Engineer:  
 VAOT  
 1-89 Over Pot Ash Brook Tributary

Project No.:	1-89 OVER POT ASH BROOK TRIBUTARY (BRIDGE NO. 67-1)
Drawing No.:	BOX CULVERT LAYOUT AND DETAILS
Project Name:	FRANK W. WHITCOMB CONSTRUCTION CORP. SOUTH BURLINGTON, VT
Project No.:	10/16/2007
Project Name:	AC IM CULV (9)
Project No.:	10/03/2007
Project Name:	VAOT
Project No.:	10/03/2007
Project Name:	VAOT
Project No.:	10/03/2007
Project Name:	VAOT

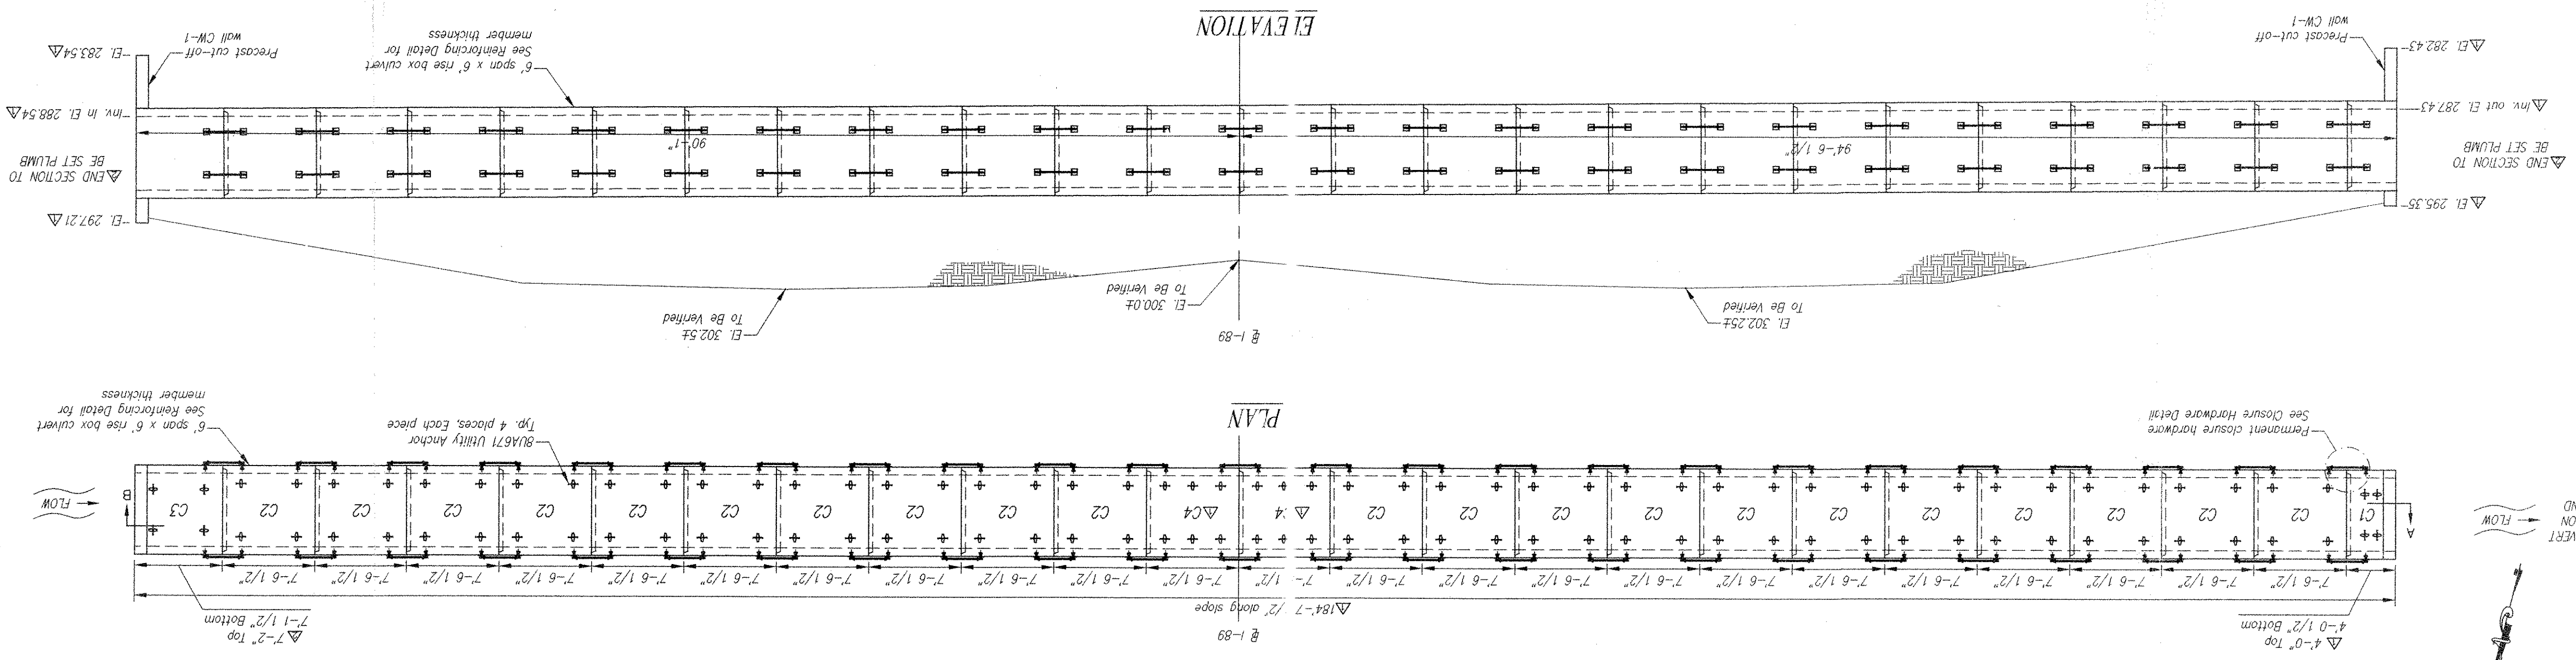
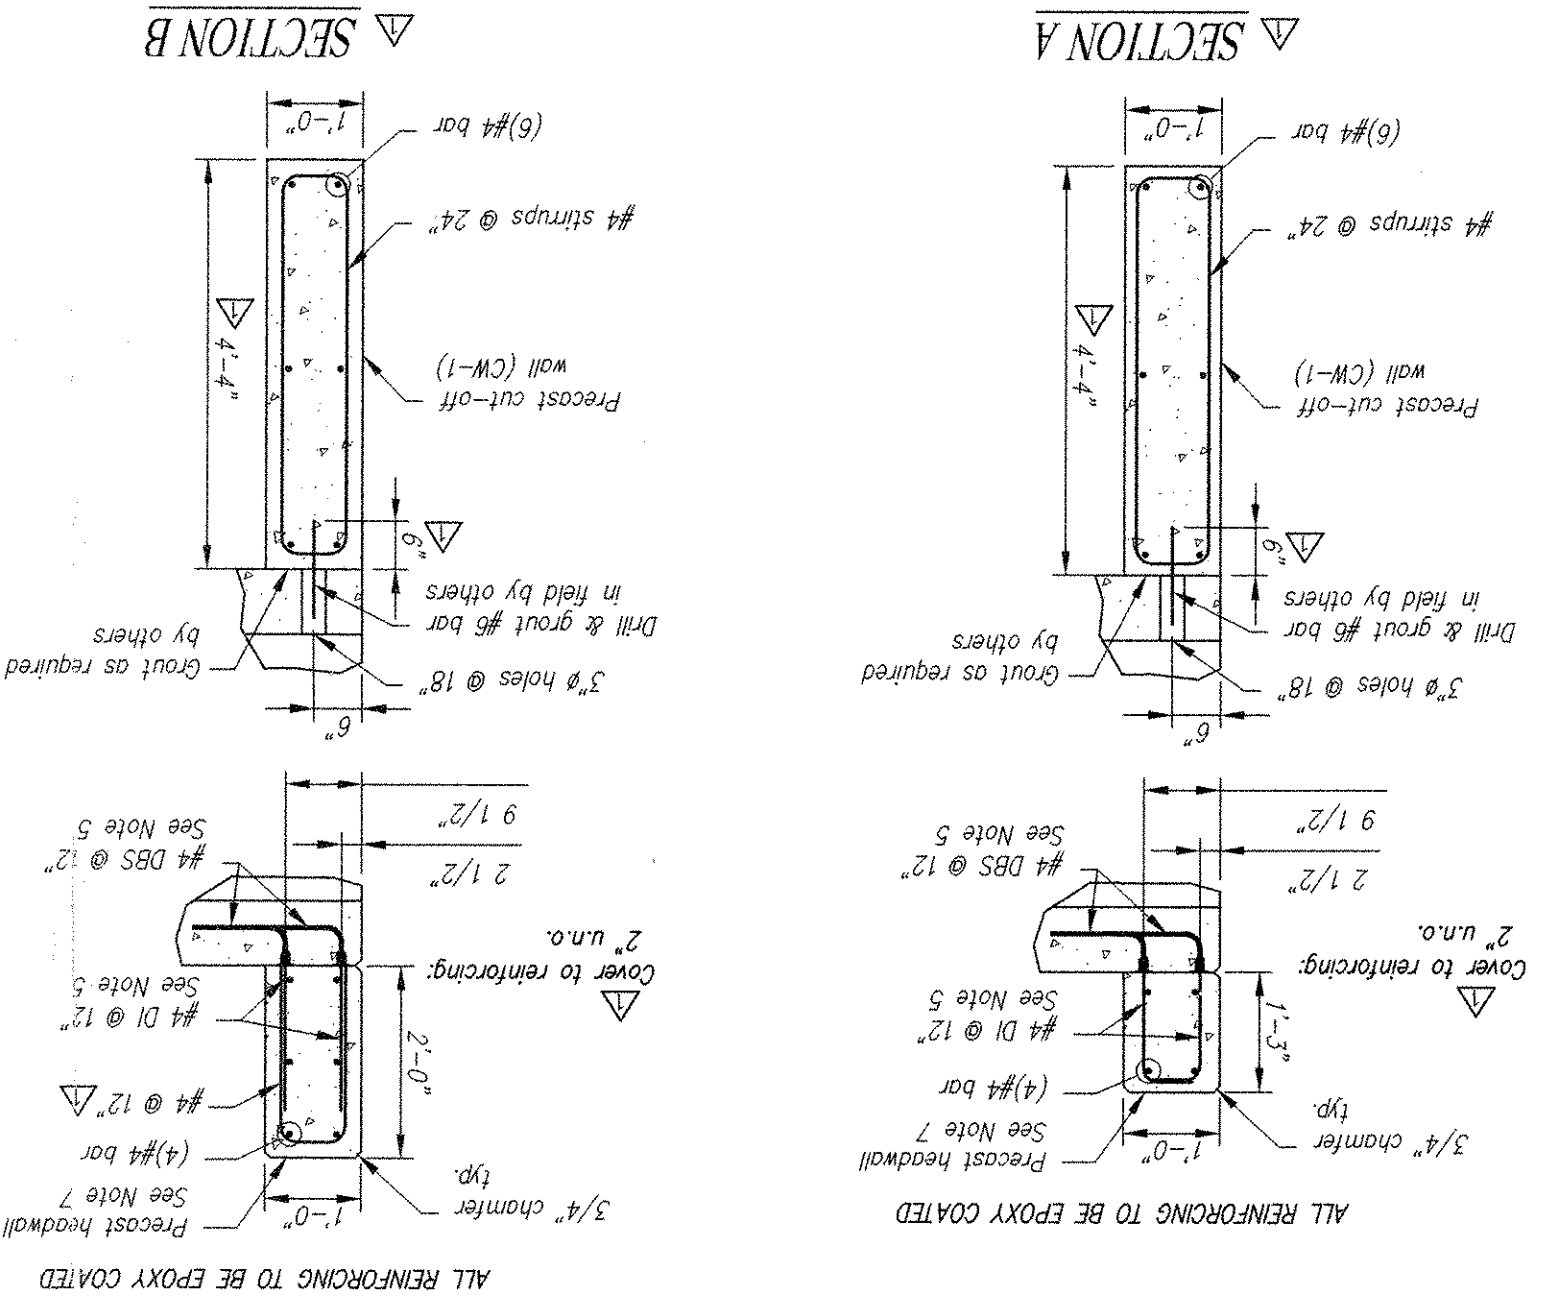
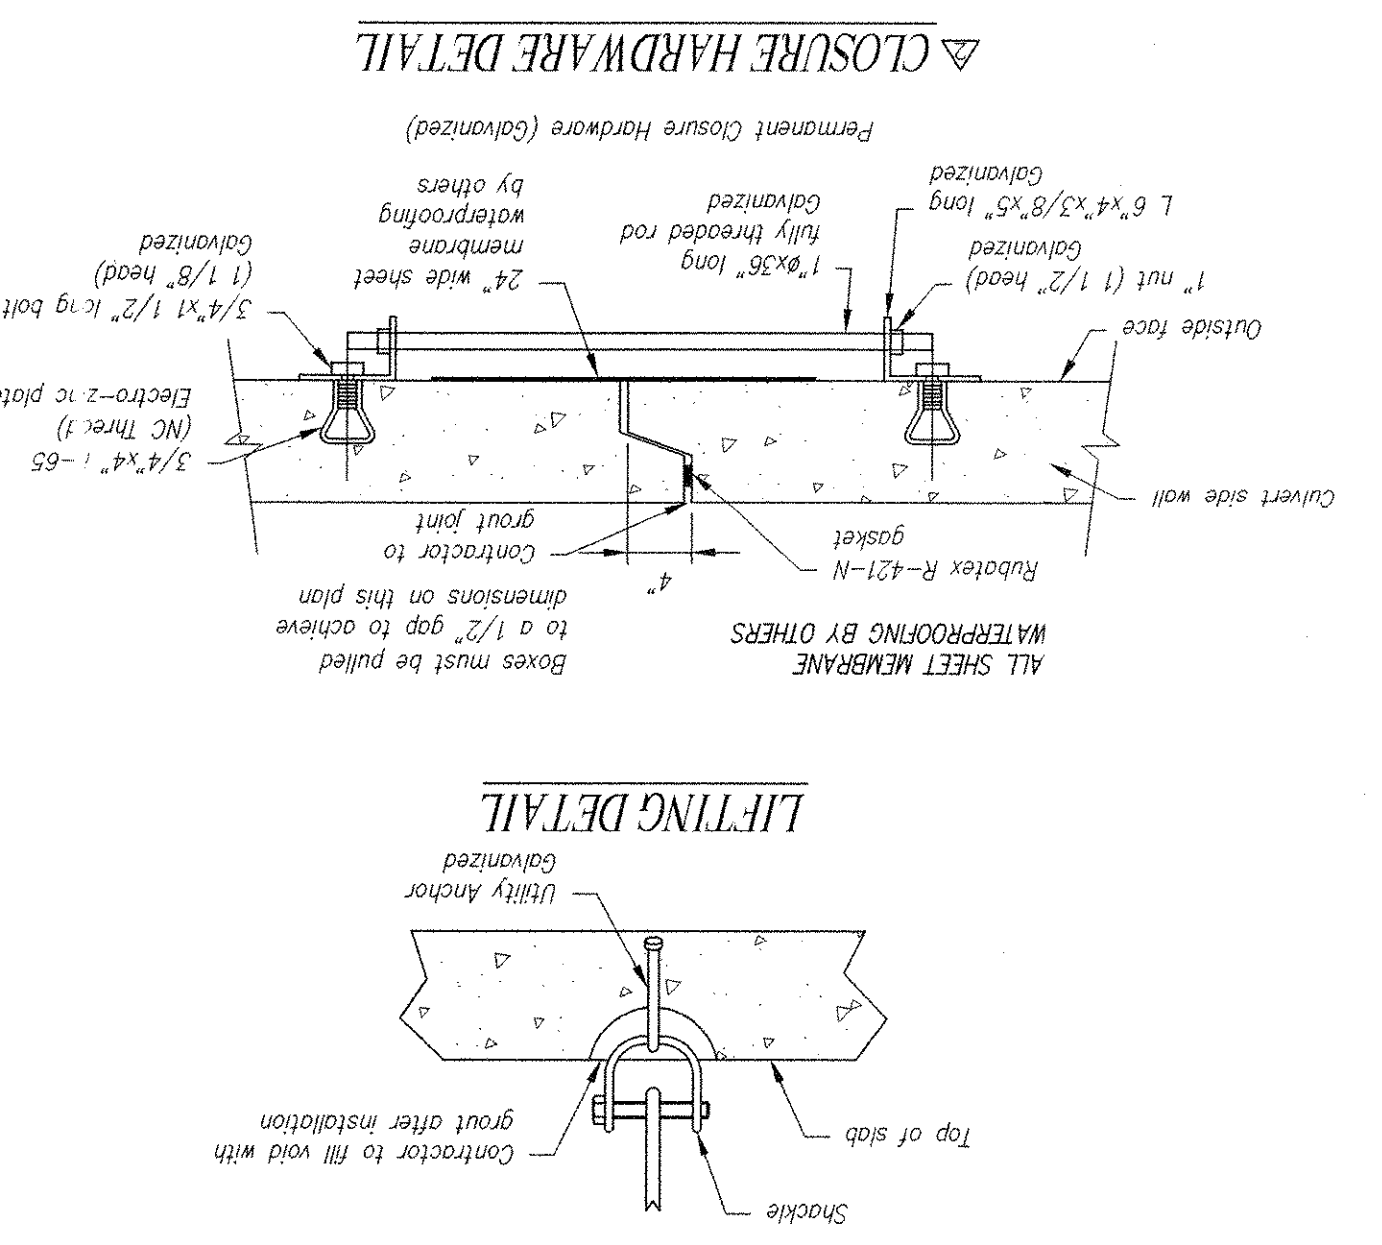
Rev.	Date	DESCRIPTION
1	10/12/07	Revised Reinforcing Detail; culvert wall thickness; cut-off walls; overall length of culvert; Misc. MS
2	10/16/07	End sections to be plumb; MK 401 @ 10"; Permanent closure hardware; Misc. revisions MS
3		
4		
5
